Access Compliance Report Public Rights-of-Way (Curb Ramps)

Main Street: AGAPANTHUS_ST		Cross Street: TUBEROSE_ST		Location:	SE
ADA ID: RPRK211111121822	Ramp Type: Type 4 - Parallel	Initial Pass/Fail: Pass	Overall Compliance: No	Severity Score:	25
Codes/Mitigation Info/Possible Solution			Field Measurements/Component Compliance

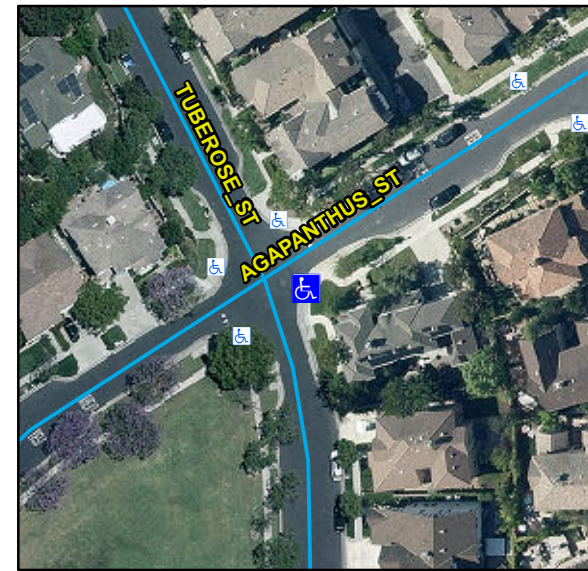
N/A	Ramp Inside Crosswalk 1	N/A	N/A	Ramp Inside Crosswalk 2	N/A
	Crossing 1 Slope (%)	2.4		Crossing 2 Slope (%)	2.1
	Crossing 1 Cross Slope (%)	0.4		Crossing 2 Cross Slope (%)	0.6
Yes	Gutter Ponding	No	Yes	Curb Slope	1.2
Yes	Gutter Lip Height (in)	0		Road Run Slope (%)	0.6
No	Gutter Run Slope (%)	12.6		Road Cross Slope (%)	2.1
Yes	Gutter Cross Slope (%)	1.8	No	Perpendicular Joint Present	No
Yes	Overall Surface Condition	Acceptable			
	Cross Gutter Present?	No		Spandrel Present?	No
	Replace Cross Gutter?	N/A		Replace Spandrel?	N/A

Remove & Replace Curb Ramp With Two New Directional Ramps or Equivalent. Remove & Replace Gutter.
